Access Compliance Report Public Rights-of-Way (Curb Ramps)

Main Street: WEMBLEY_RD Cross Street: CHESNEY_DR Location: W

ADA ID: RPAT211201090206 Ramp Type: Type 1 - Perpendicular Diagonal Initial Pass/Fail: Fail Overall Compliance: No Severity Score: 15

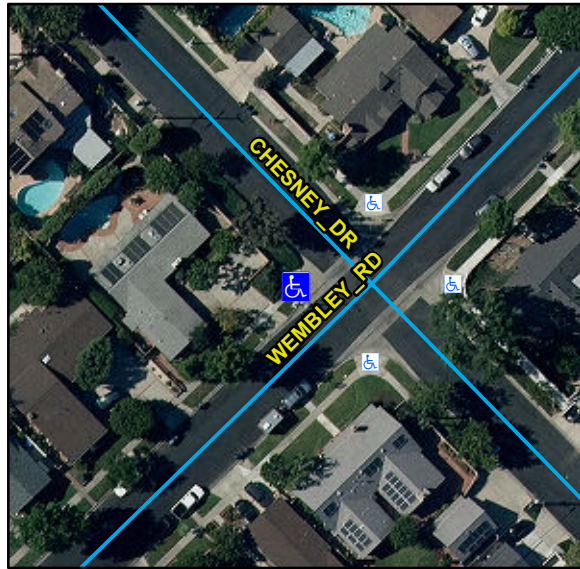
Remove & Replace Curb Ramp With Two New Directional Ramps or Equivalent.

R304.2.2, R204.3, STD 1115
